Re: Building 200, 300 and 800 Modernization  
RFP No 20-21-18  
Addendum #4

**Project: BUILDING 200, 300 and 800 MODERNIZATION**

Project Title  
**IMPERIAL VALLEY COLLEGE  
 BUILDING 200, 300 AND 800 MODERNIZATION**

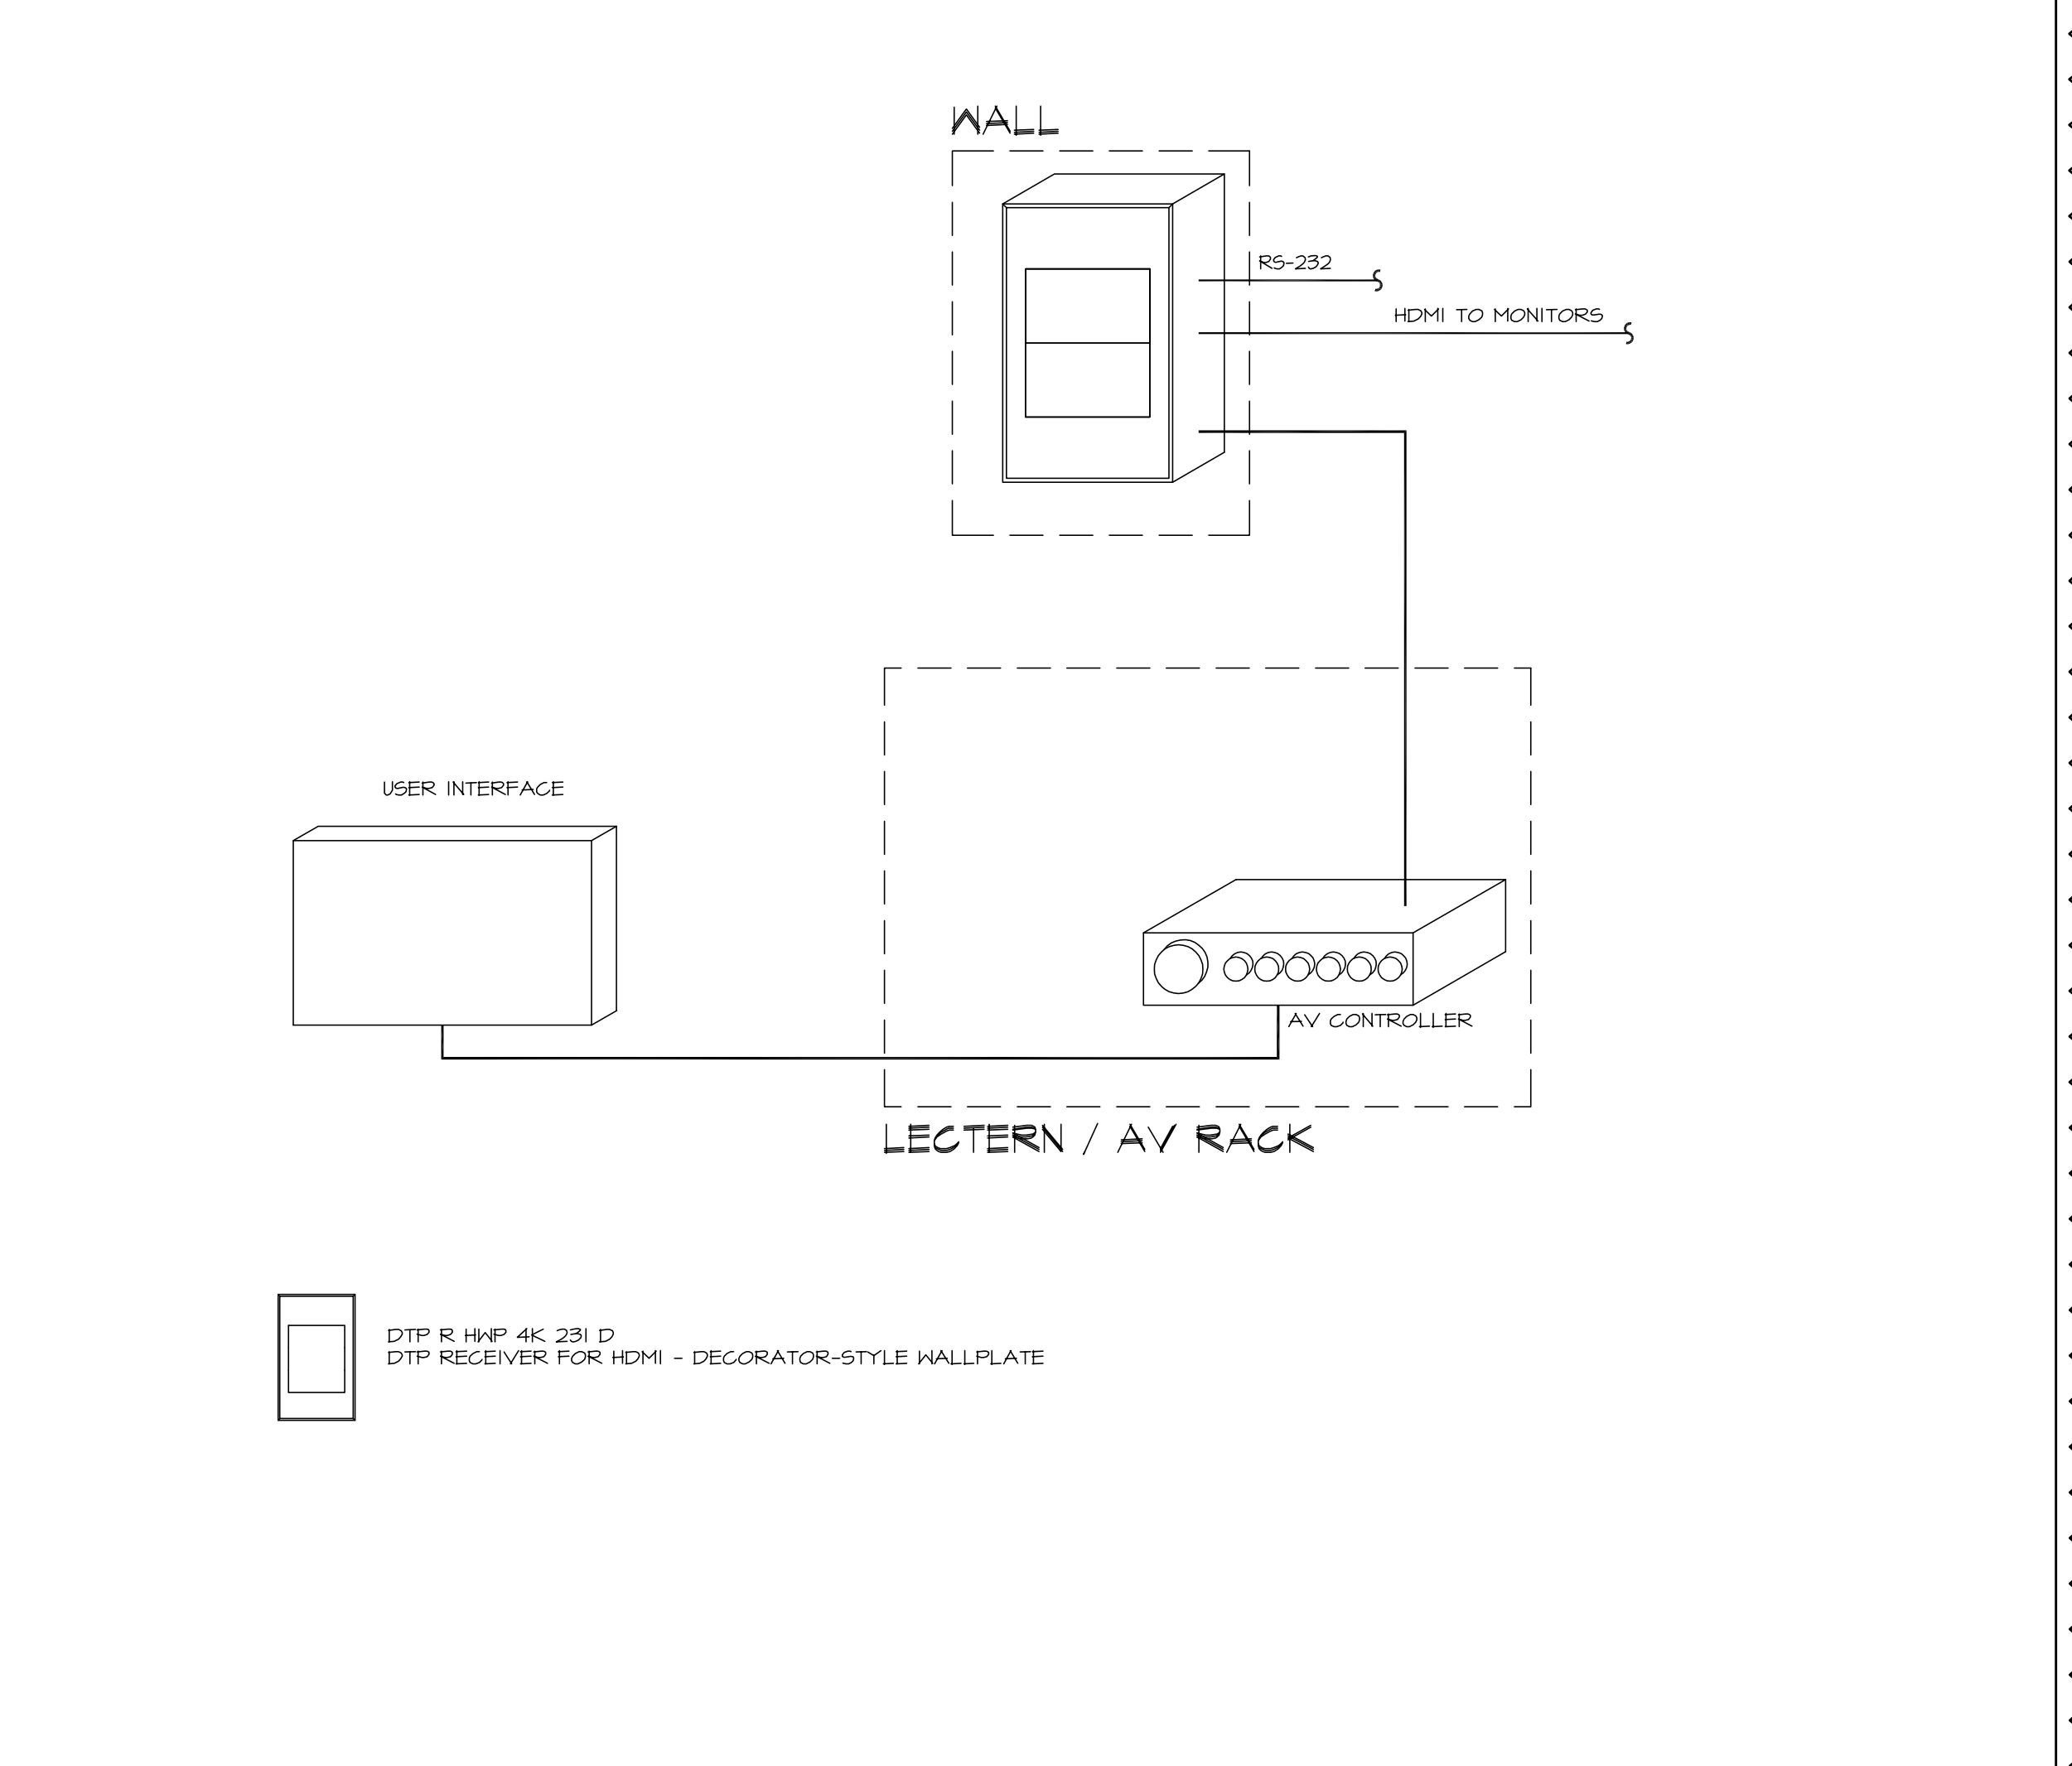
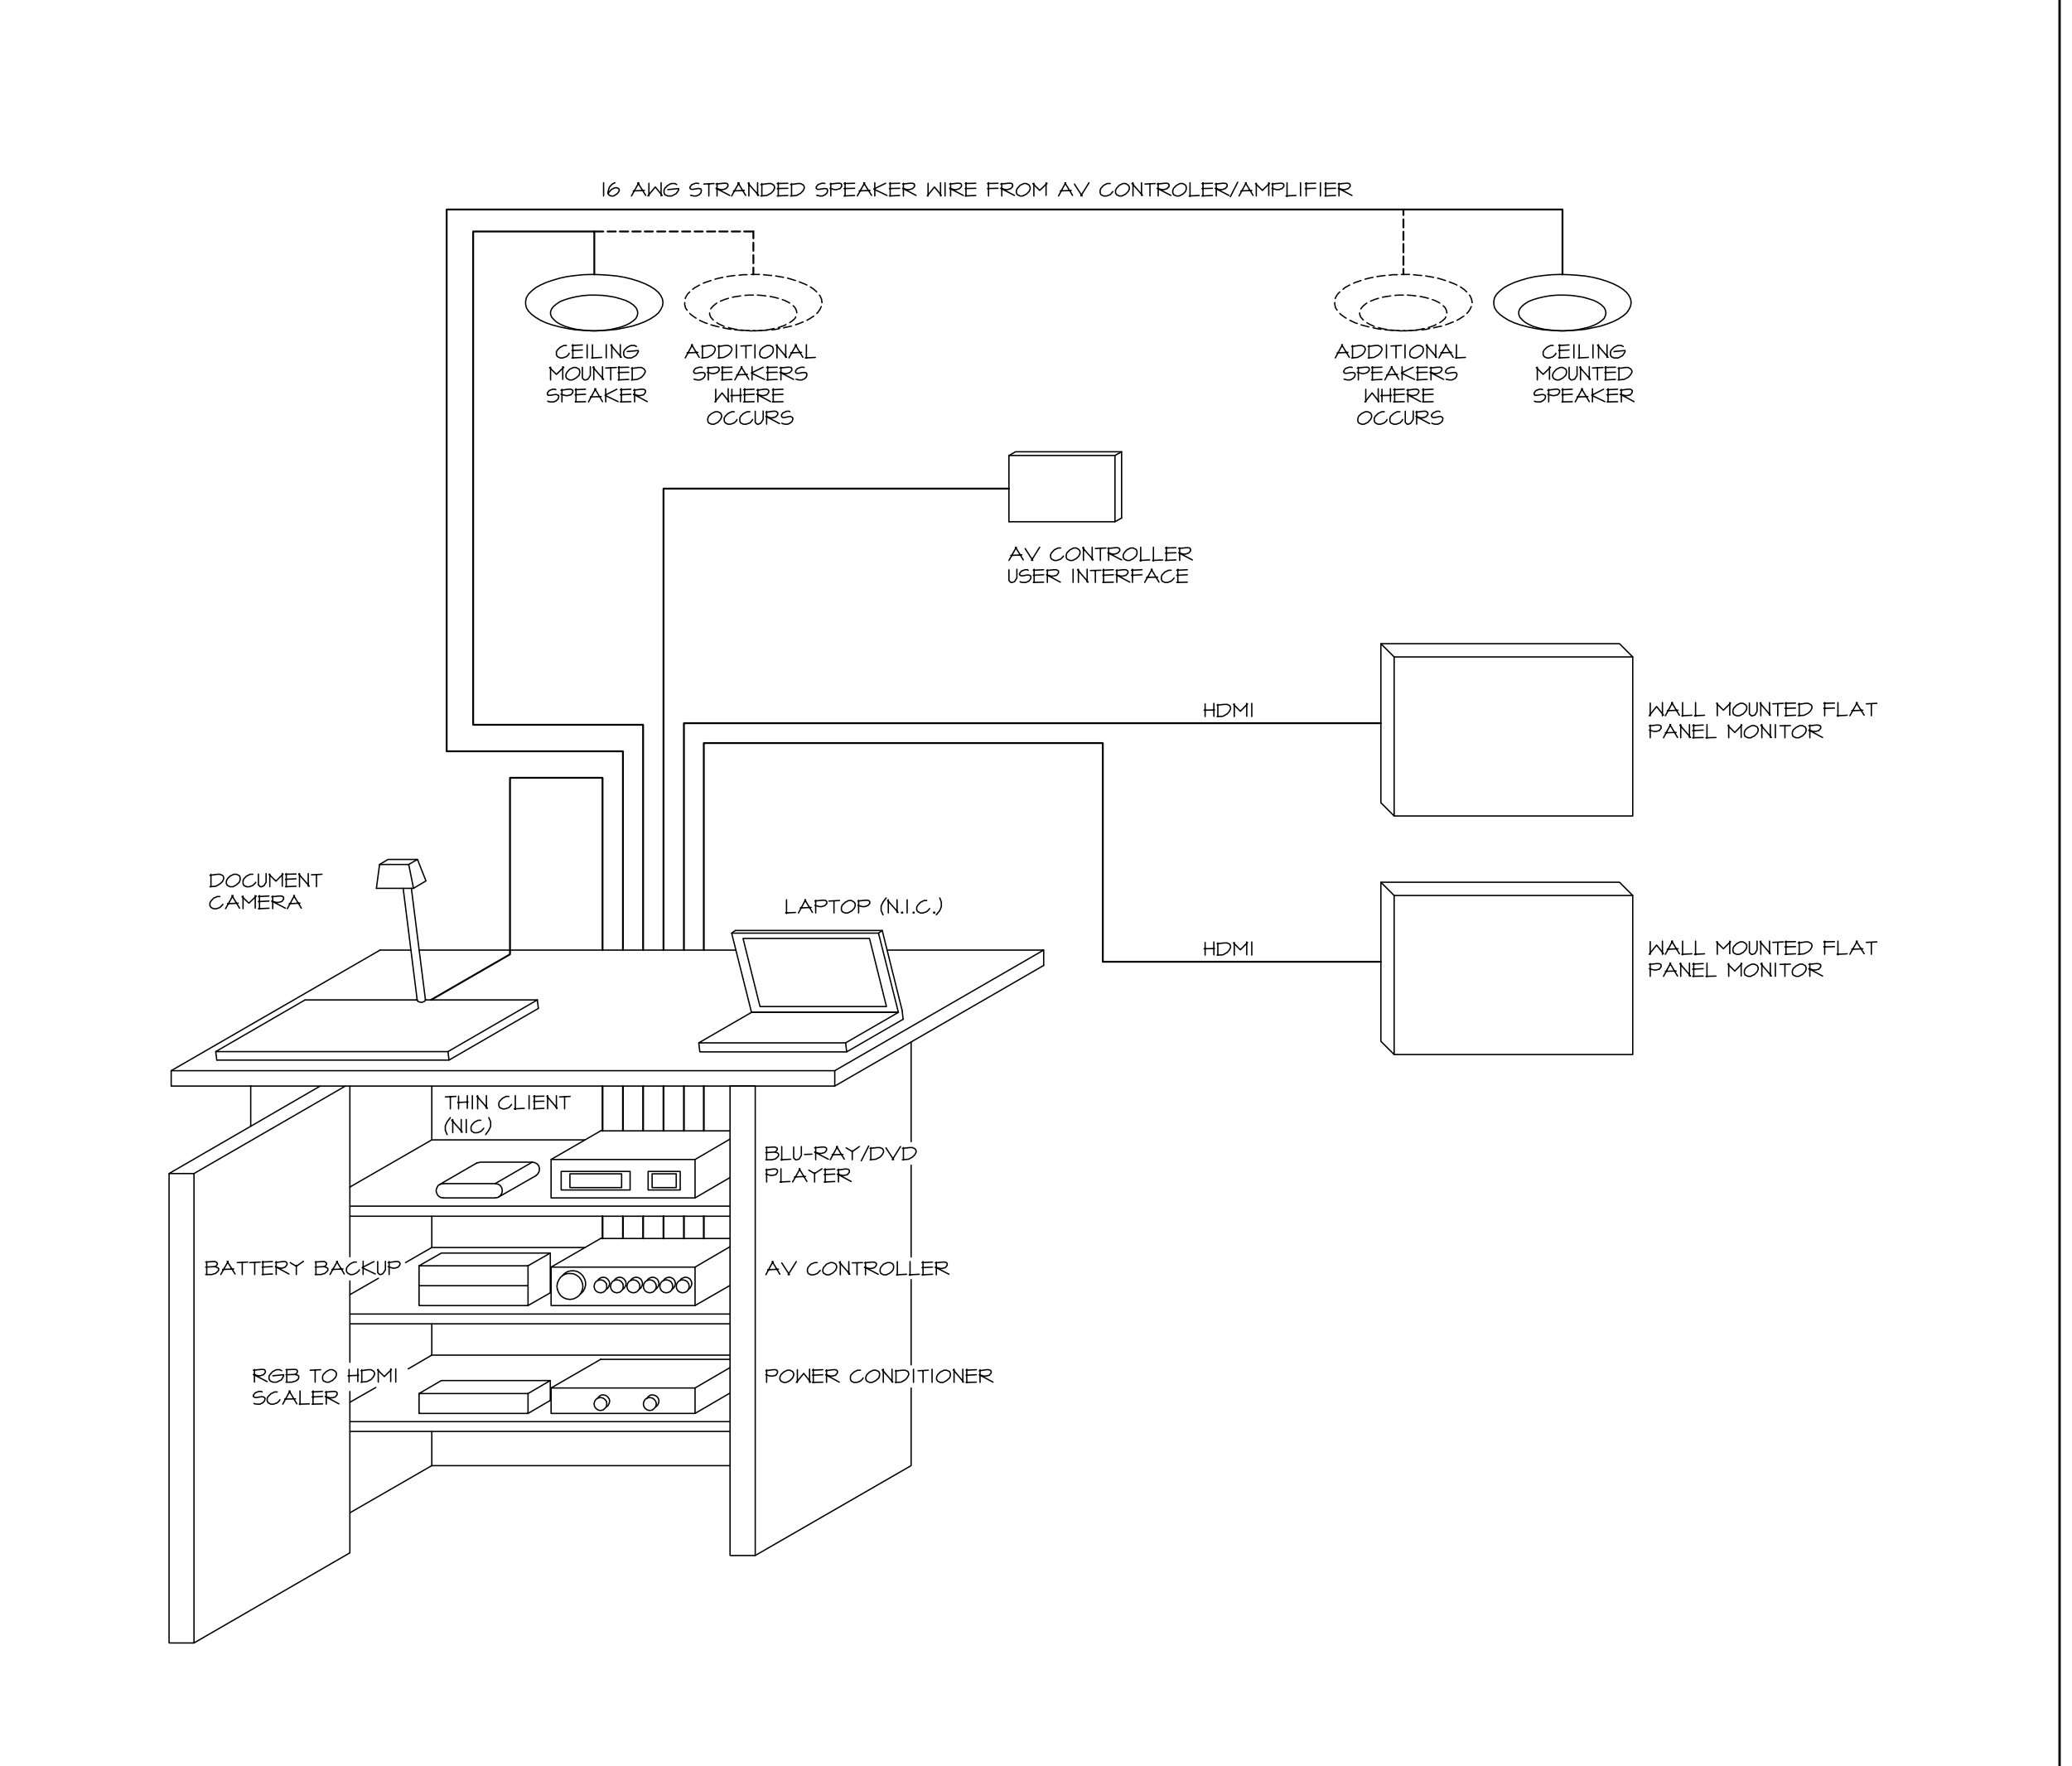
2. SHEET CM0.2 – COMMUNICATIONS DETAILS
  - a. Sheet CM0.2 shall be replaced by Drawing AD-4\_CM0.2 attached to this addendum: changes are clouded.
3. SHEET CM0.3 – COMMUNICATIONS DETAILS
  - a. Sheet CM0.3 includes Details 1, 2 and 4 in error. Details 1, 2 and 4 shall be deleted.
4. SHEET CM2 – COMMUNICATIONS PLAN
  - a. Sheet CM2 shall be replaced by Drawing AD-4\_CM2 attached to this addendum: changes are clouded.
5. SHEET CM3 – COMMUNICATIONS PLAN
  - a. Sheet CM3 shall be replaced by Drawing AD-4\_CM3 attached to this addendum: changes are clouded.
6. SHEET CM8 – COMMUNICATIONS PLAN
  - a. Sheet CM3 shall be replaced by Drawing AD-4\_CM8 attached to this addendum: changes are clouded.
